RECEIPT DATE: 2/28/18 **ONSITE SEWAGE DISPOSAL SYSTEM**

PROPERTY ADDRESS: 15320 Galaxy Drive

SUBDIVISION: Fairlane Farms

**RE: OSDS Plan
15320 Galaxy Drive**

VICINITY MAP

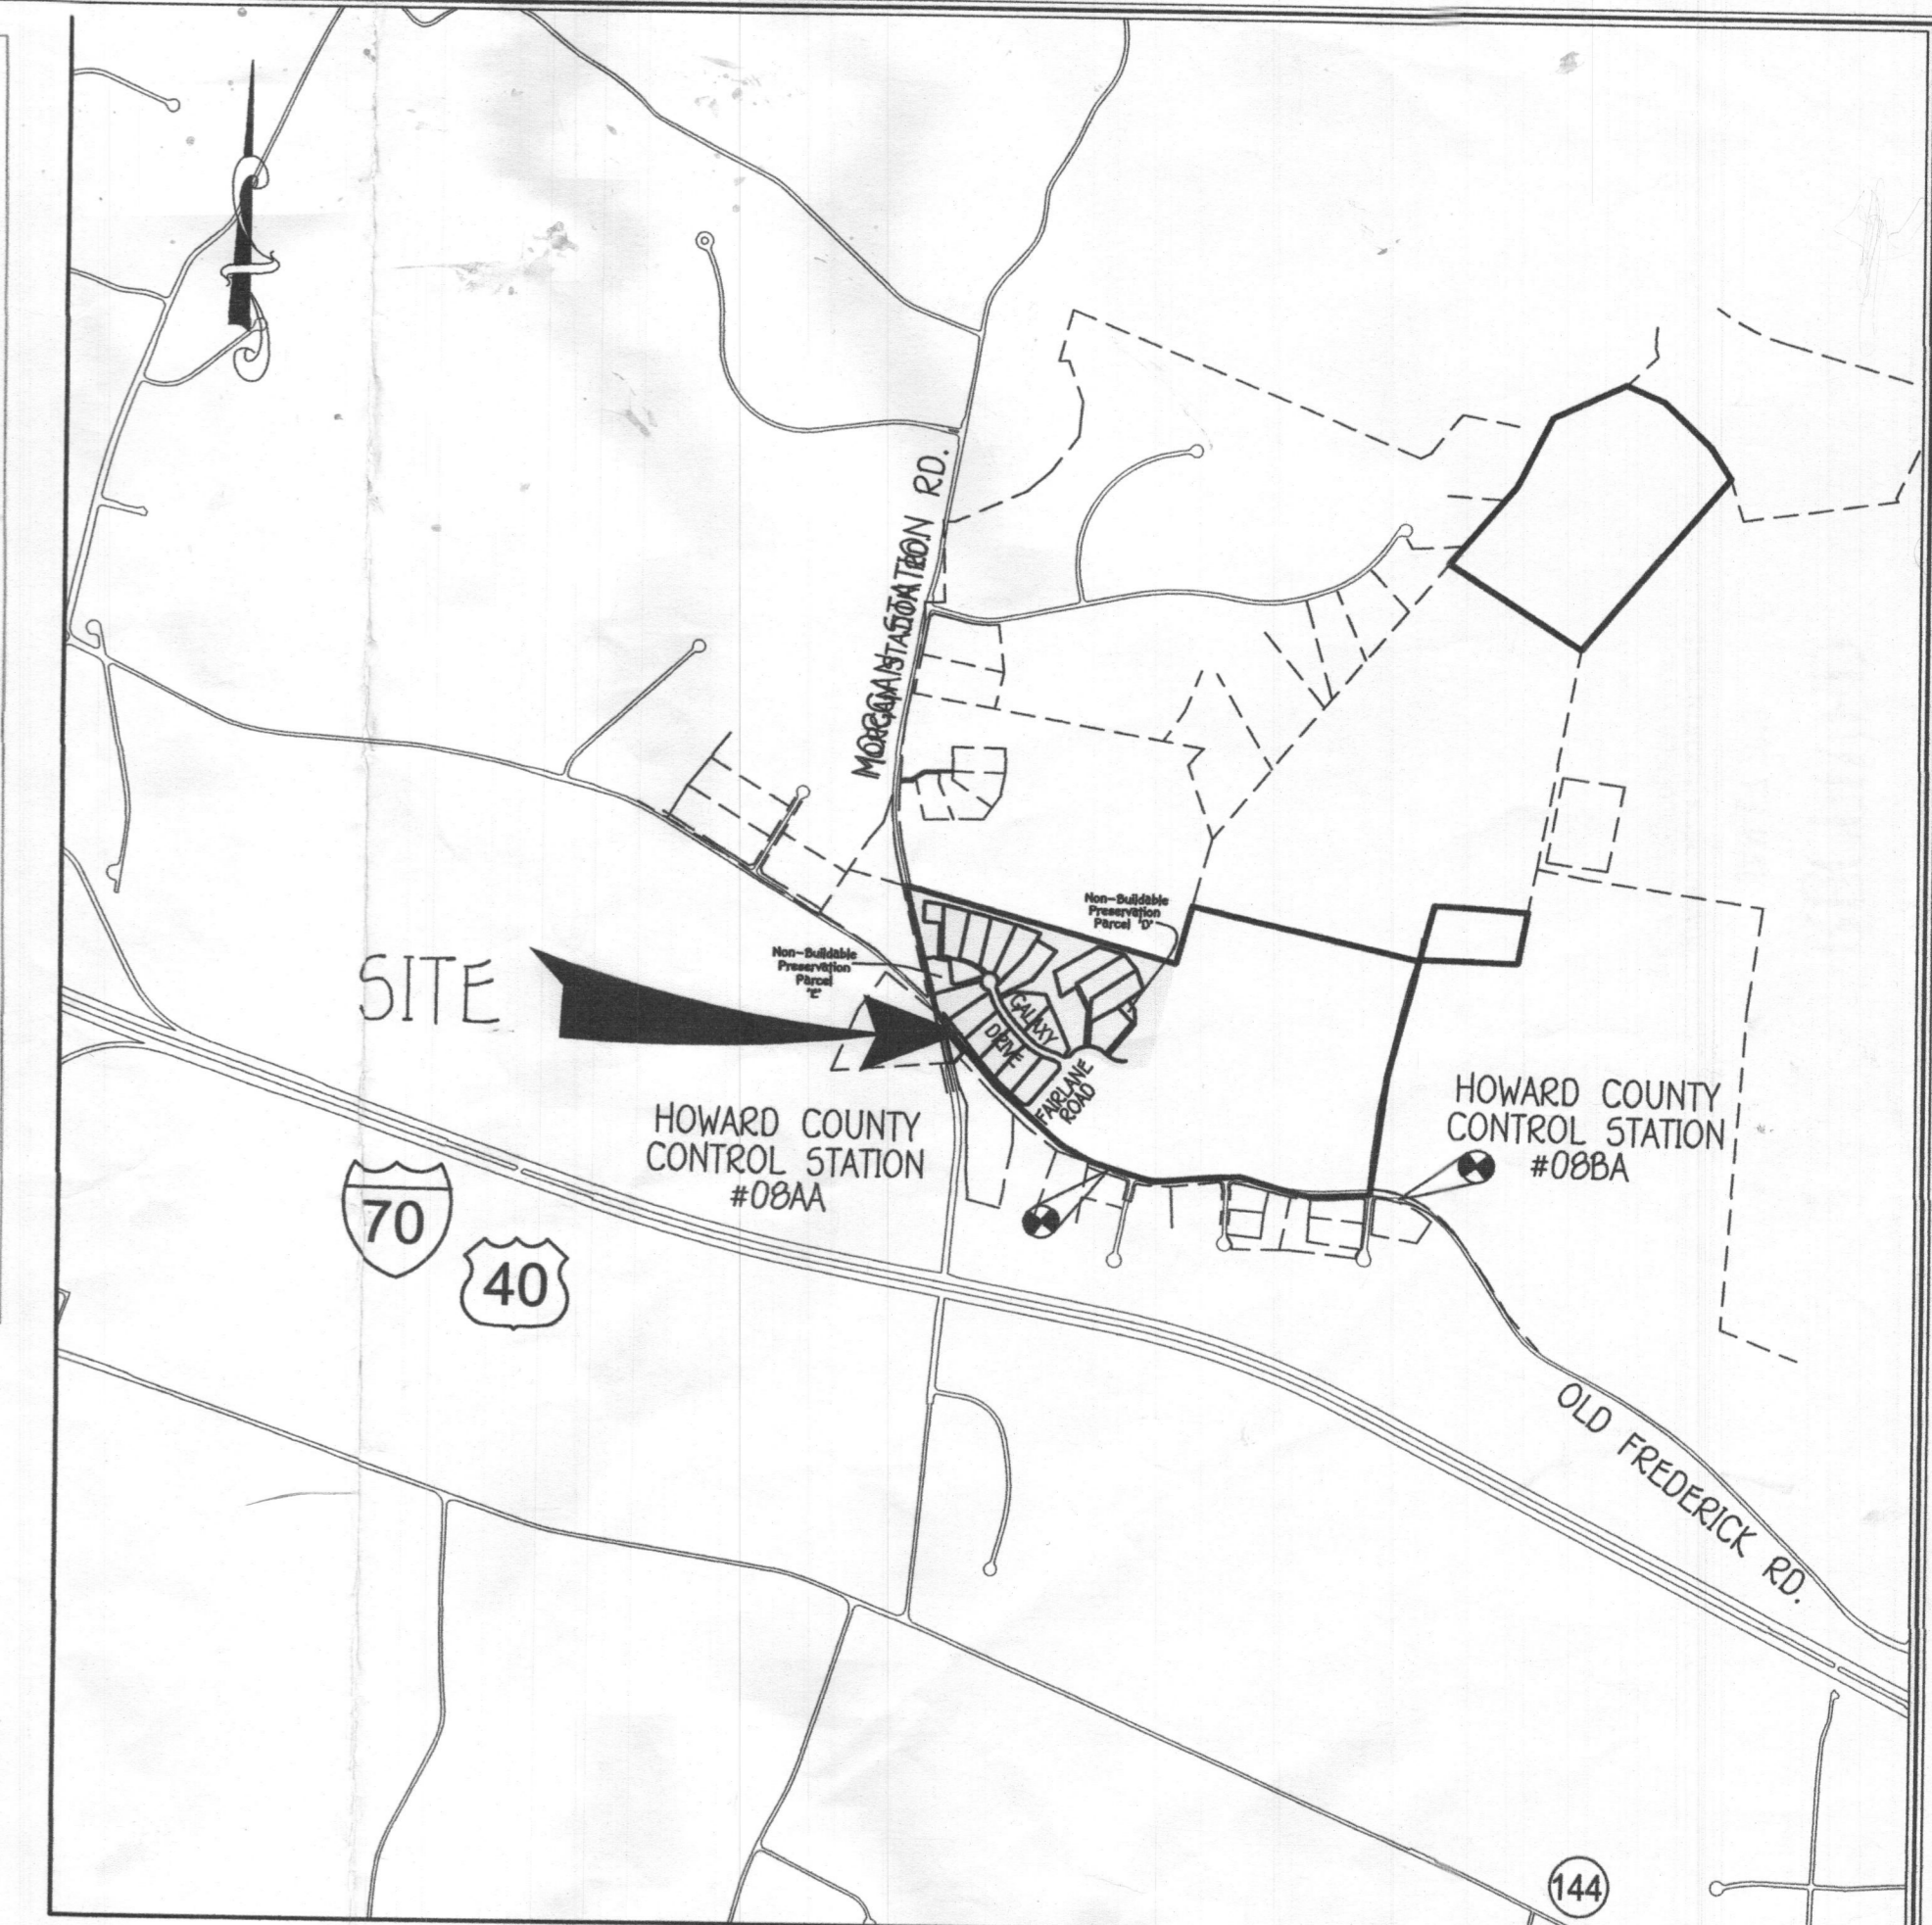
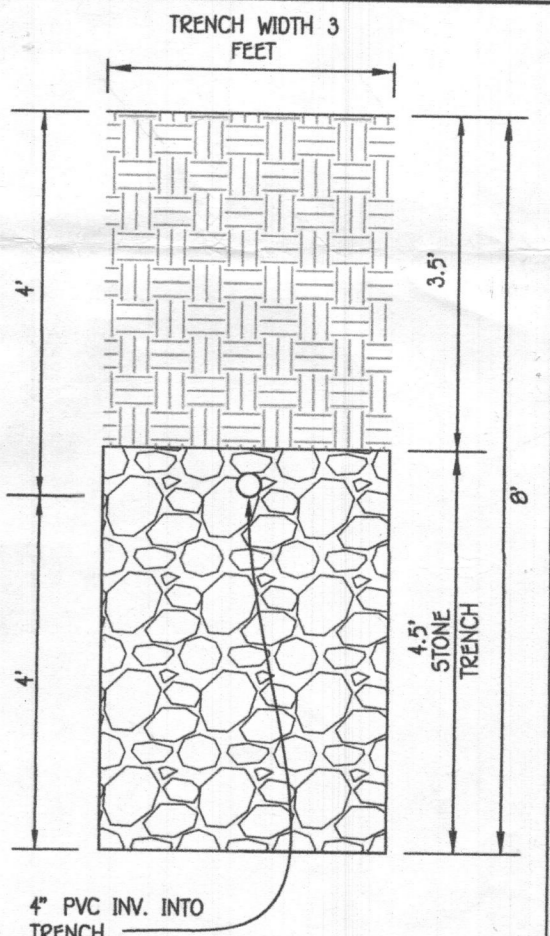
The floor plan for 5320 Galaxy Drive shows 6 bedrooms (1 B.R./Home Office in the basement and 5 B.R. on the second floor) but the septic plan is only sized for 5 bedrooms. In addition, the building permit site plan shows the morning room within 20 feet of the septic tank (the setback is at least 20 feet). Please revise the floor plans or the septic plan and BP site plan accordingly.

- 1.) The septic tank does not meet the 20 foot setback to residence.
- 2.) The sidewall credit for initial system should be 0.625 (not 0.556) in your calculation. However, you could use up to 3.5 feet of sidewall credit reducing the required length of trench (See attached septic specs)
- 3.) Application rate for 1st replacement system should be 0.8 (not 0.6)
- 4.) Application rate for 2nd replacement system should be 0.6 (not 0.8)
- 5.) Align trench data with trench detail. The difference between grade and bottom of trench should be 8 ft. (not 7.9 ft.).
- 6.) Match septic profile BSE (597.10) with BSE on plan (596.92).
- 7.) Trench Depth for initial and replacement system should be 8 feet (not 7 and 7.5 respectively) in calculations.

- 1.) Initial system sidewall credit calculation has a 2 in it but should be a 3.5. Otherwise 0.45 is still correct.
- 2.) First system calculation is not utilizing entire sidewall credit of 3.5 feet. It is not mandatory but it would reduce required trench length to approx. 141 feet.
- 3.) Show space between d-box and initial trench on plan. In general, label trenches a little better. Please be sure that trench lengths on plan match calculated lengths.
- 4.) Define 2nd replacement trenches and label (i.e. show 4 separate trenches)
- 5.) Make septic tank 20 feet from house.
